AGENDA
CHASKA PLANNING COMMISSION
ZOOM
Wednesday, March 10, 2021
7:00 PM

REQUEST FOR ACTION
CHASKA PLANNING COMMISSION
03/10/2021

Subject: **Corporate and High Bay Industrial - Chaska Creek Business Park – Final Site & Building Plan and Final Plat (Chaska Creek Center 3rd Addition)**

Sheet No. Revision
C3.03

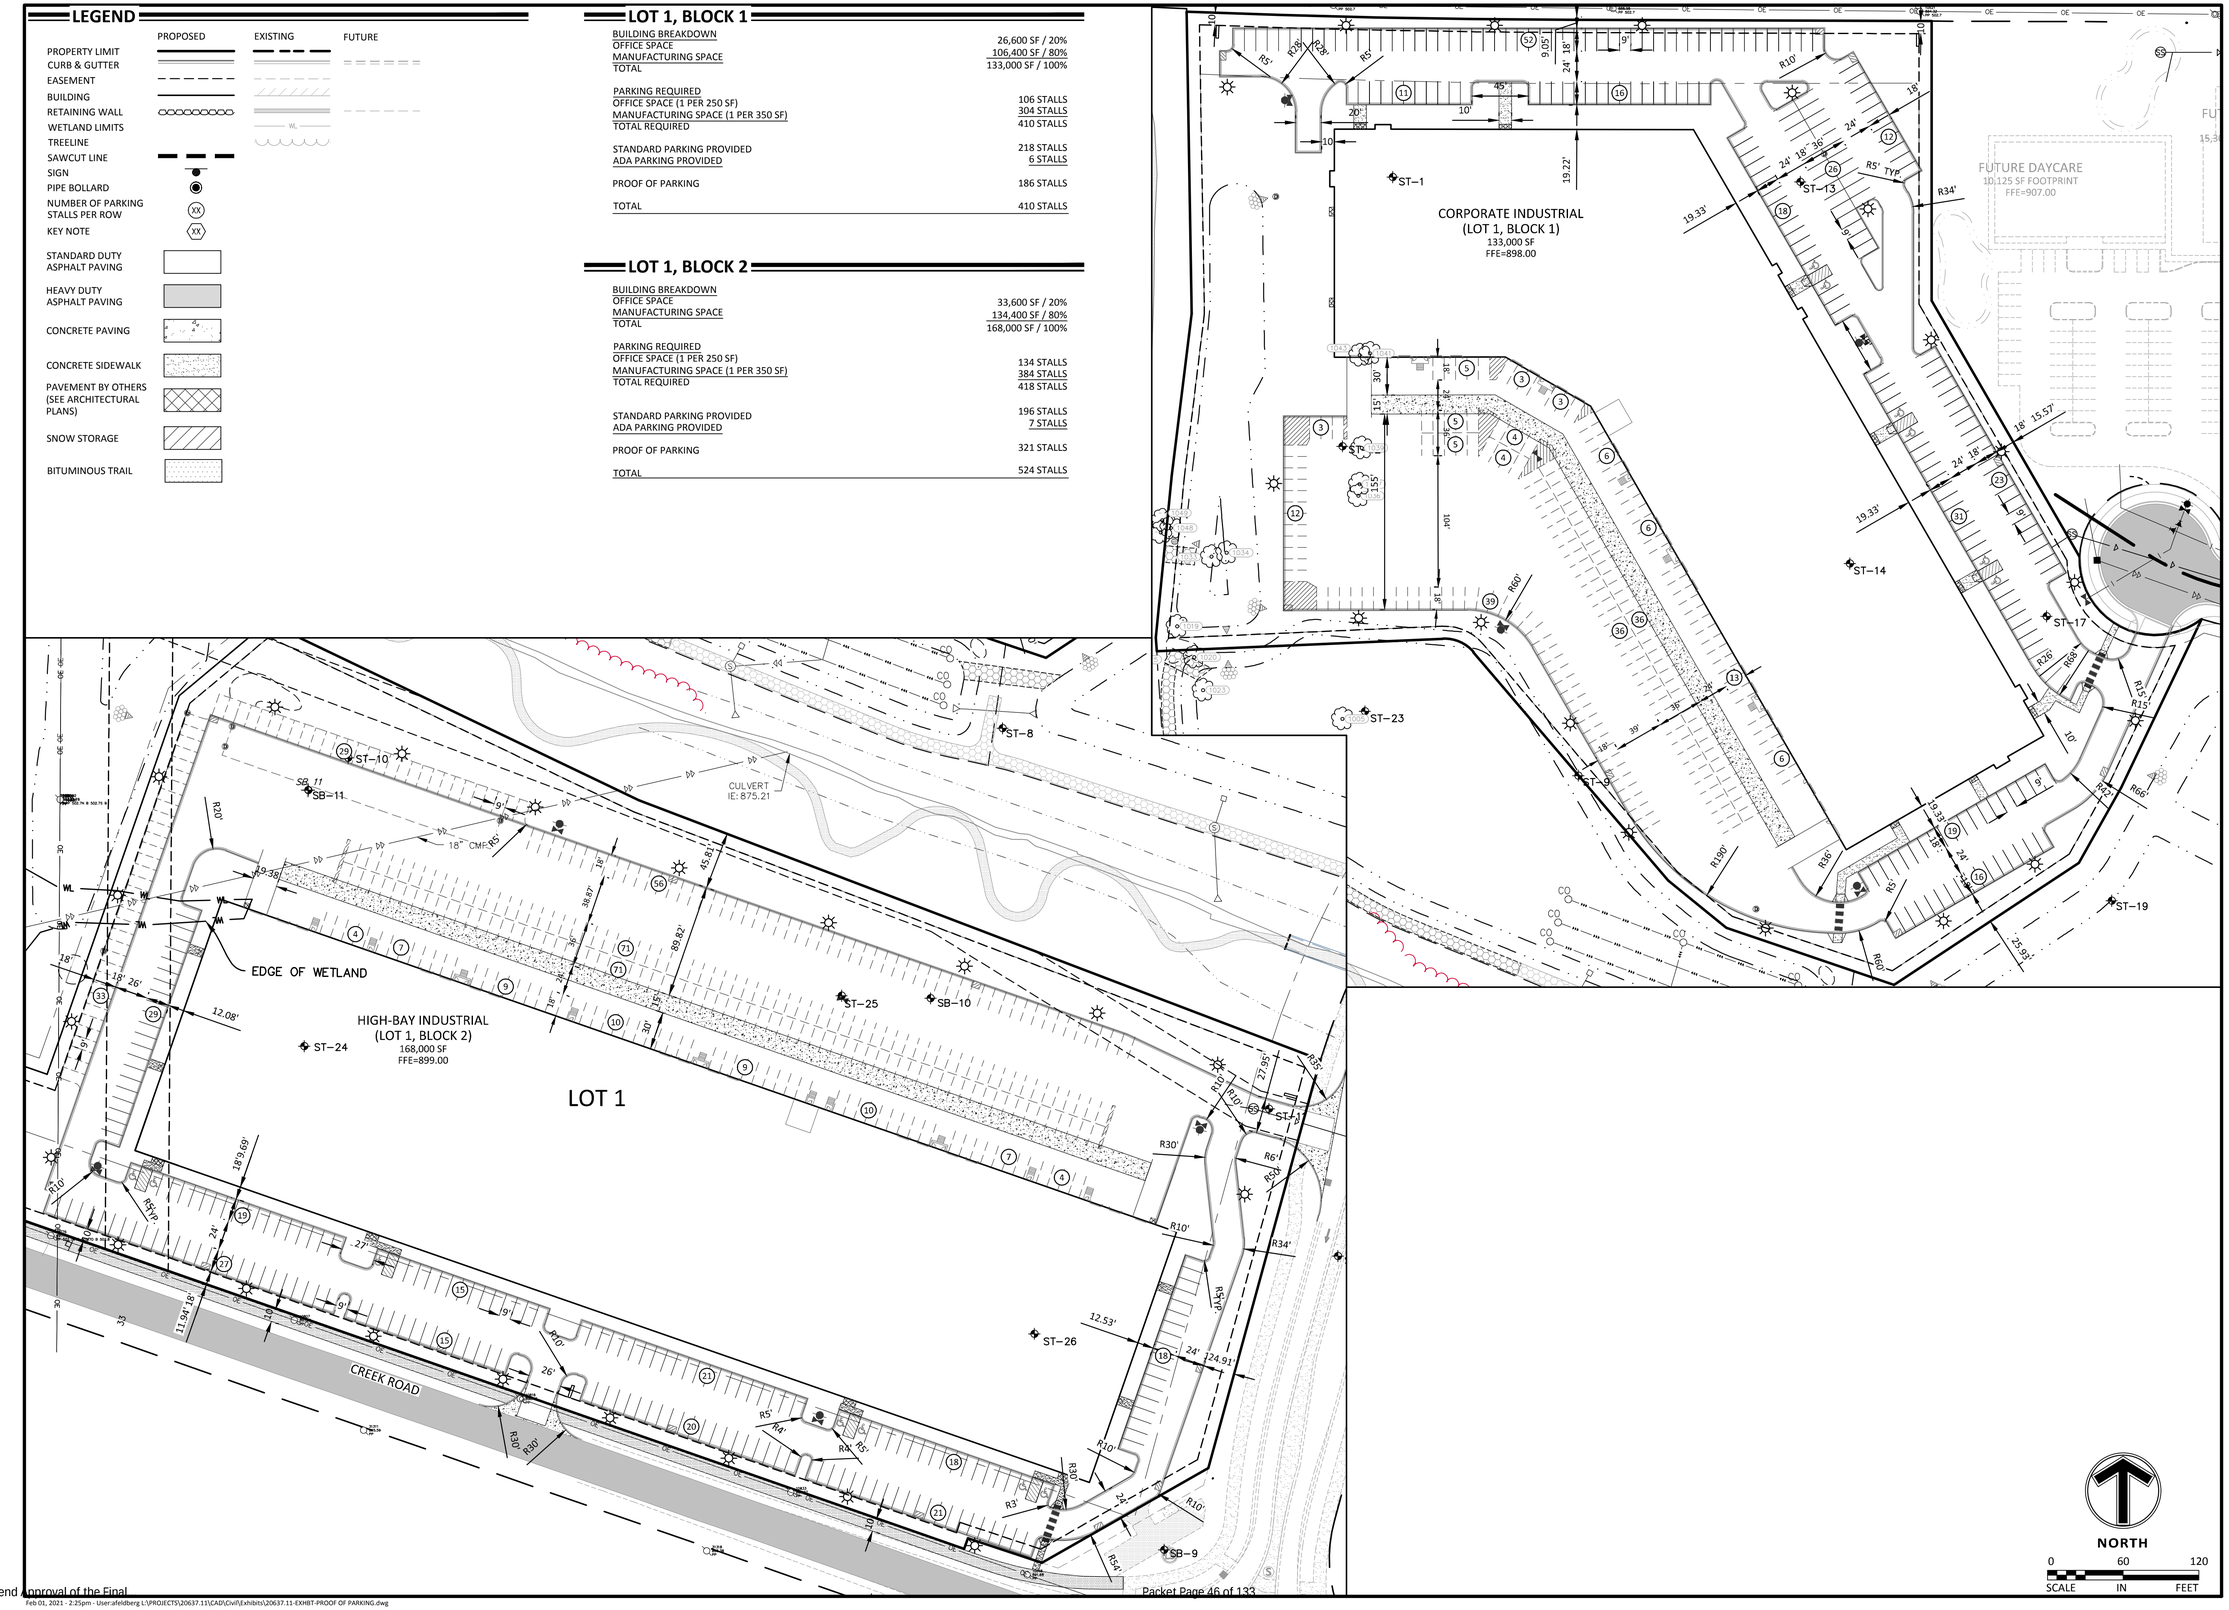
13. Provision of Lot 1, Block 2's southeasterly drive aisle to meet the required 10-foot setback from property lines, and to be revised on the final submittal.

Response: Sheet C3.03, Site Plan – Lot 1, Block 2 shows a separation of 10 feet from the proposed temporary lift station improvements and the back of curb of the southeasterly drive aisle.

Sheet No. Revision
C3.04

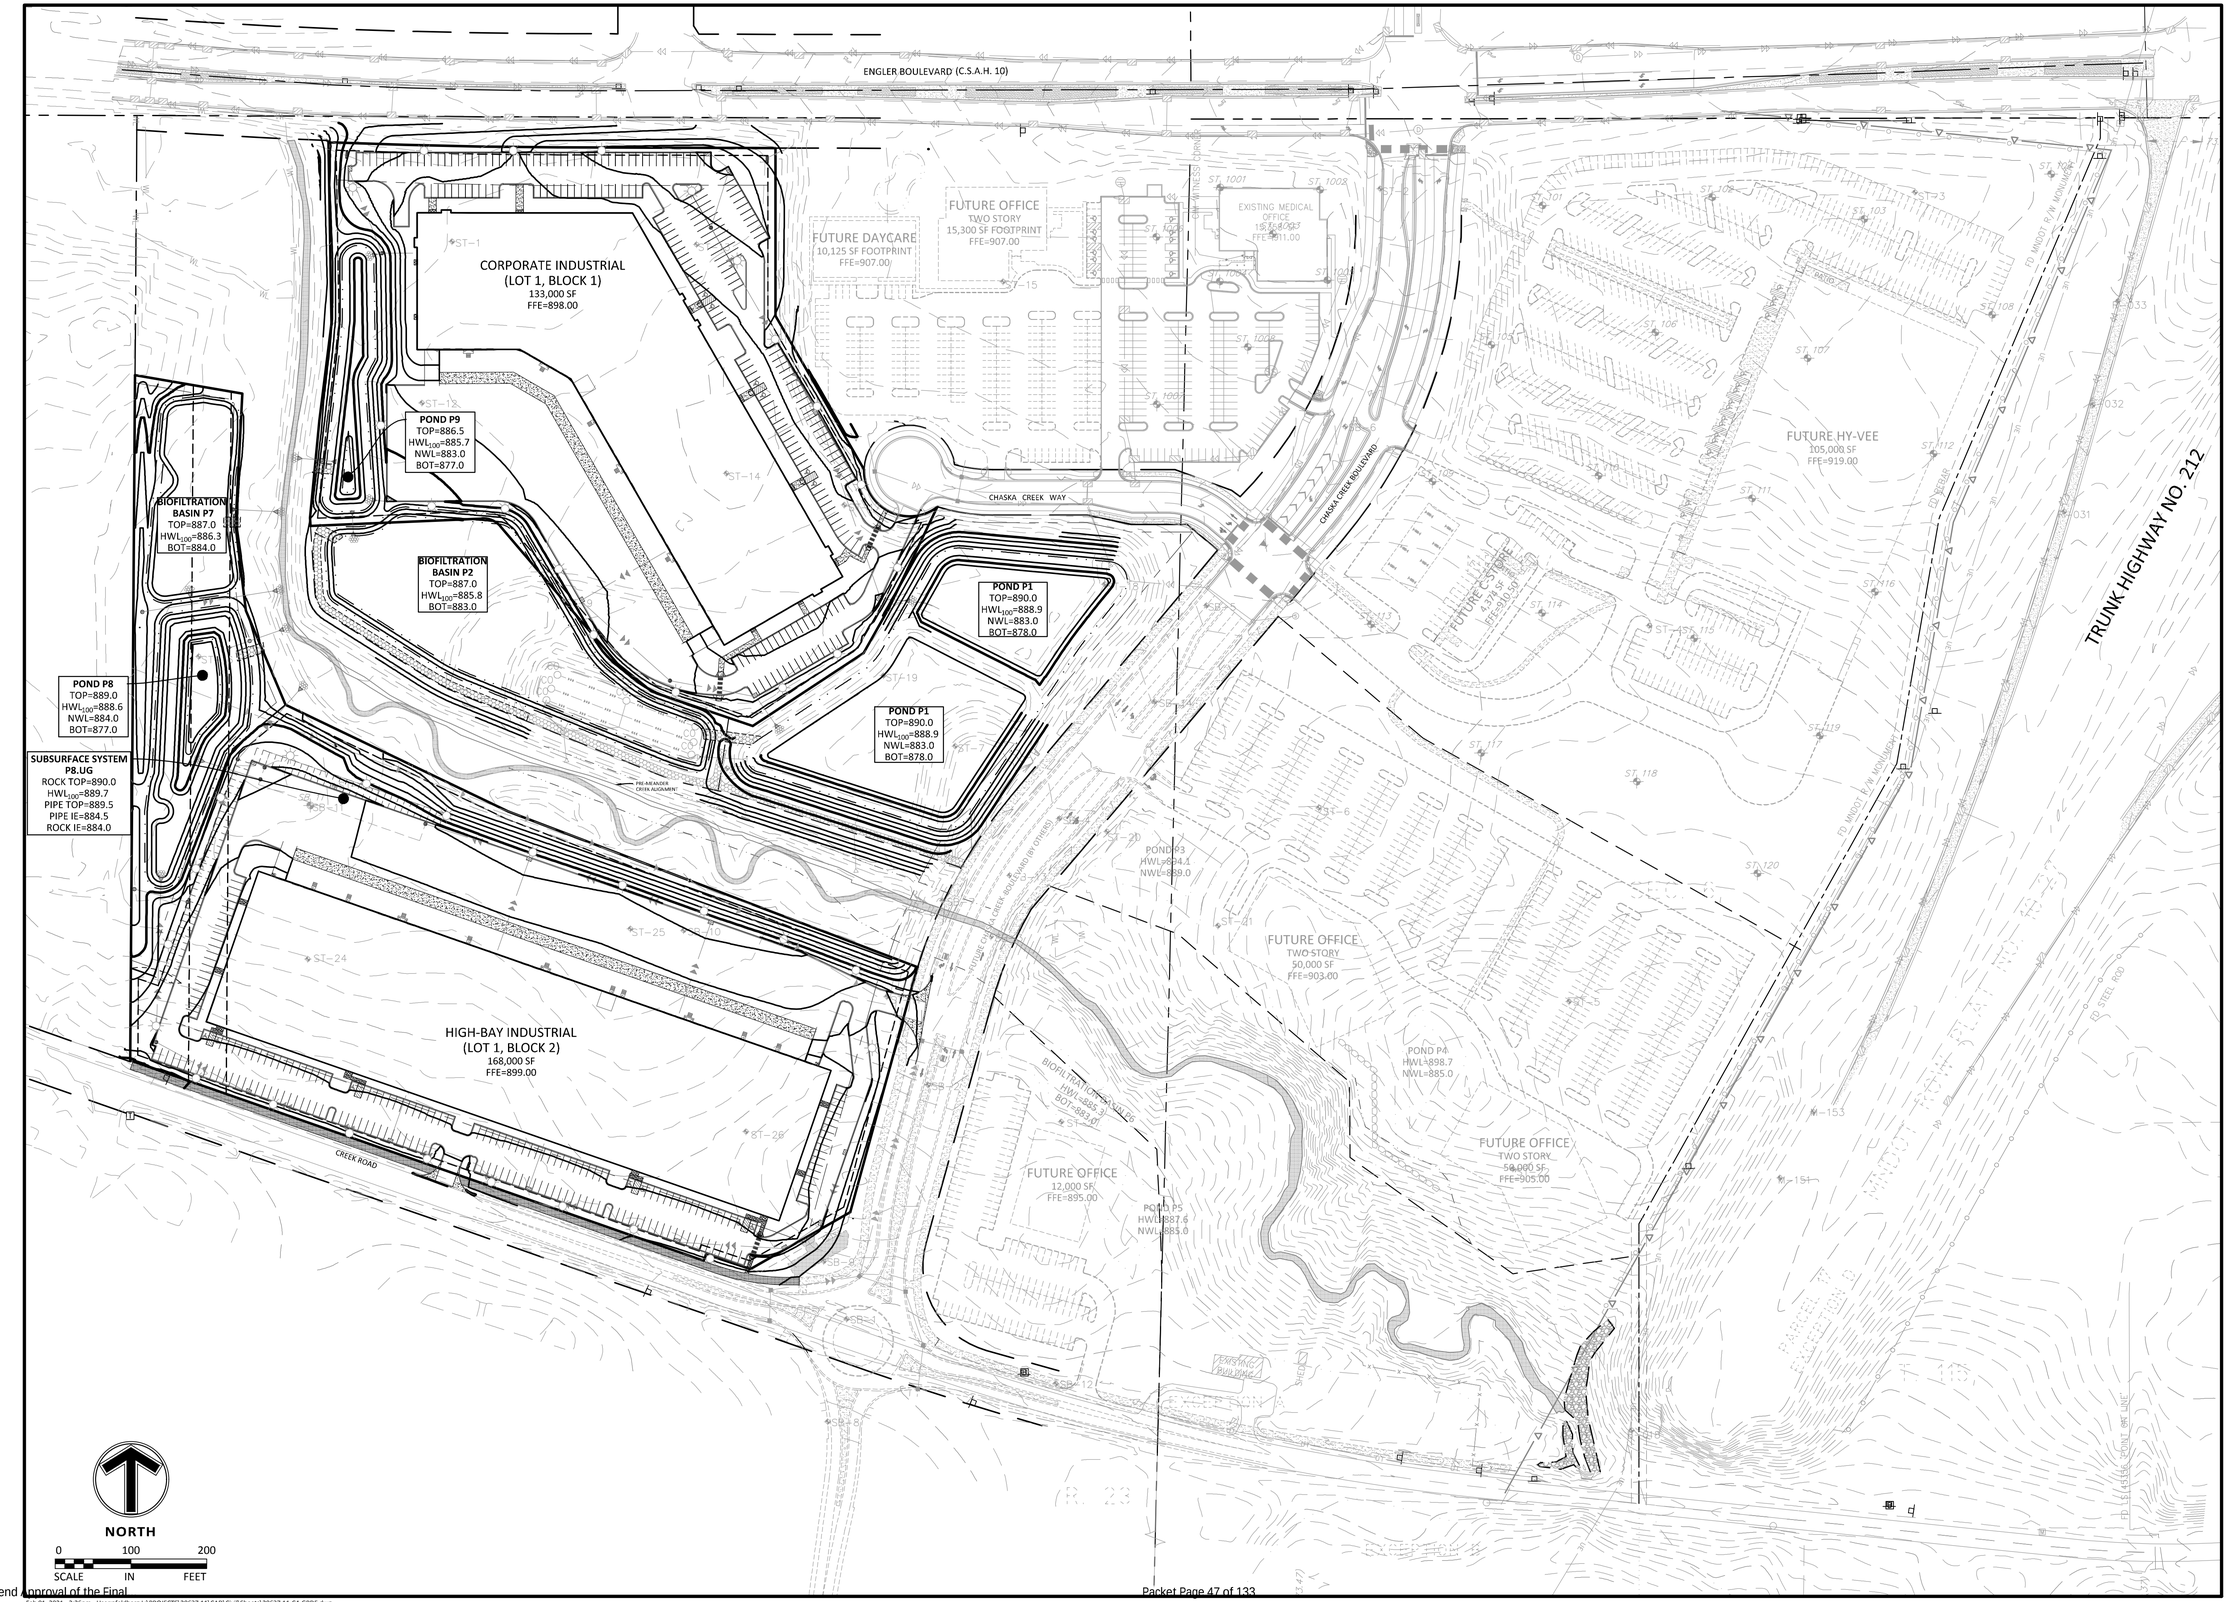
10. Provision of a parking plan to show 1 parking stall per 350 square feet of warehouse space on each site, and to be submitted at final submittal.
11. Provision of prominently coniferous shrubs on the south edge of Lot 1, Block 2, and to be addressed in the landscape plan at final submittal.

Response: Acknowledged, Sheet C3.04 Site Plan – Proof of Parking has been added to the plan set demonstrating the required warehouse parking stalls.
